Road Safety Audit Review

Town:	Highgate	Date Reviewed:	January 19 2016
Route:	VT 78 @ ST Armand Rd and Lamkin St	Mile points:	VT 78: 3.07

Concern: Corner Sight Distance Issue when Looking West from St Armand Road

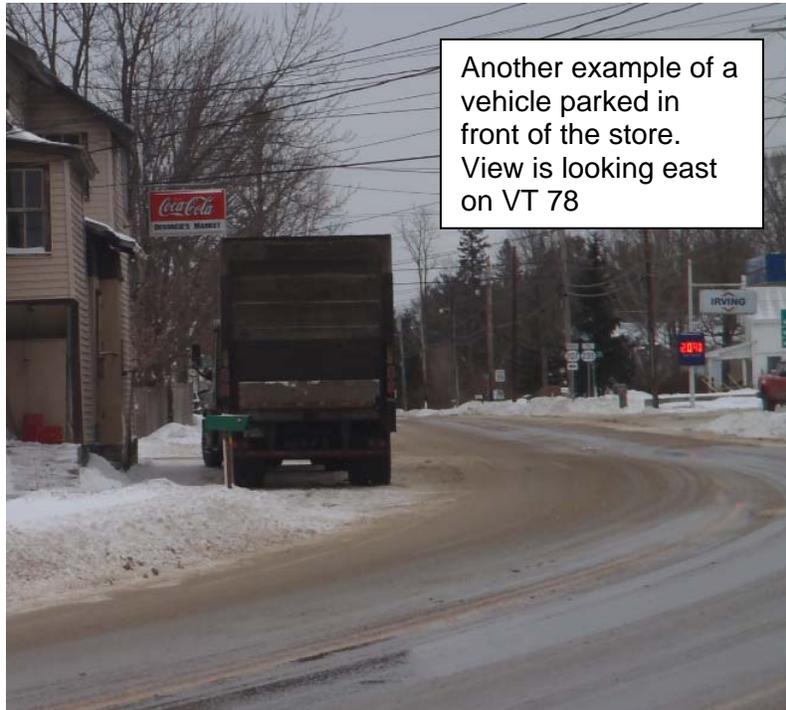
The corner sight distance when stopped on St Armand Road and looking to the right (or west, is inadequate (measured to be 175 feet compared to desired 335 feet for a speed of 30 mph). The horizontal curve to the west of the intersection contributes to this issue.

When a vehicle is parked in front on the store, adjacent to VT 78, this issue is heightened and corner sight distance is practically zero. The delivery location in front of the store is also a factor.

Ensure that a clear sight triangle to the west of St Armand Road is provided.

Consideration should be given for the installation of "No Parking on the Travelled Way" sign along with crosshatched markings. A more efficient solution would be for the Town to request the Traffic Coordinating Committee that a no parking zone be instituted.

Note, Intersection Sight Distance (ISD) for 35 mph is 390 ft and 335 ft for 30 mph as per AAHSTO
